Access Compliance Report

Public Rights-of-Way

Intersection ID: 24414	Main Street: MICHAEL_SHANE_CT	Cross Street: WRIGHT'S_FERRY_RD	Location: NW
ADA ID: 08043E8FC6B2	Ramp Type: BlendTrans2	Initial Pass/Fail: Pass	Overall Compliance: No
Severity Score: 15			
Codes/Mitigation Info/Possible Solution		Field Measurements/Component Compliance

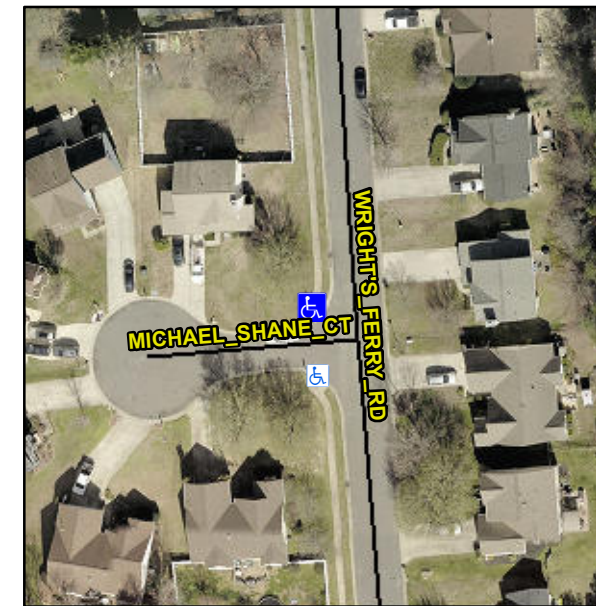
Not Found, R305, R304.5.4

Compliance	Description	Data	Compliance	Description	Data
N/A	Ramp Length (in)	96.0	Yes	BlendTrans Slope (%)	2.8
Yes	Ramp Width (in)	80.3	Yes	BlendTrans XSlope (%)	1.2
N/A	Flare Type LT	None	N/A	Flare Type RT	None
N/A	Flare Slope LT (%)	N/A	N/A	Flare Slope RT (%)	N/A
N/A	Flare Traversable LT?	N/A	N/A	Flare Traversable RT?	N/A
N/A	Landing Length (in)	N/A	No	DWS Provided?	No
N/A	Landing Width (in)	N/A	N/A	DWS Contrast?	No
N/A	Landing Slope (%)	N/A	N/A	DWS Length (in)	N/A
N/A	Landing X Slope (%)	N/A	N/A	DWS Full Width?	No
N/A	Landing Curb? (Y/N)	No	N/A	DWS Offset (in)	N/A
N/A	Shared Landing?	No			
Yes	Gutter Ponding?	No	No	Gutter Slope (%)	8.7
Yes	Gutter Lip Ht (in)	0.0	Yes	Gutter X Slope (%)	0.9
N/A	Painted X Walk1?	No	N/A	Painted X Walk2?	No
	X Walk 1 Direction	To S		X Walk 2 Direction	To E
	X Walk 1 Width (in)	N/A		X Walk 2 Width (in)	N/A
	X Walk 1 Slope (%)	0.2		X Walk 2 Slope (%)	2.8
	X Walk 1 X Slope (%)	2.3		X Walk 2 X Slope (%)	0.1

N/A	Ramp inside XWalk1?	N/A	N/A	Ramp inside XWalk2?	N/A
	Road Slope (%)	0.6		Clear Space?	Yes
	Road X Slope (%)	2.4	N/A	Clear Space to XWalk (in)	N/A
Yes	Any Obstructions?	No	Yes	Storm Grate/Utility Hazard?	No
	Obstruction Type			Storm Grate/Utility Type	
		N/A			N/A
			Yes	Surface Condition? (G/P)	Good
			No	Curb Slope (%)	12.7

Remove & Replace Curb Ramp With Two New Directional Ramps or Equivalent. Remove & Replace Gutter.
